WARREN AVENUE BRIDGE
MULTIMODAL PROJECT
OPEN HOUSE

Warren Avenue Bridge Multimodal Project Open House | April 24, 2023

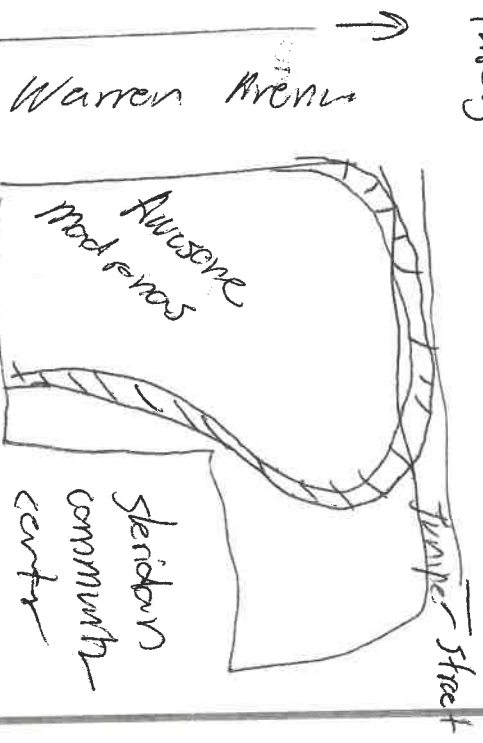
Don't swale the north off bridge concept through forest too much

gently curve down through park
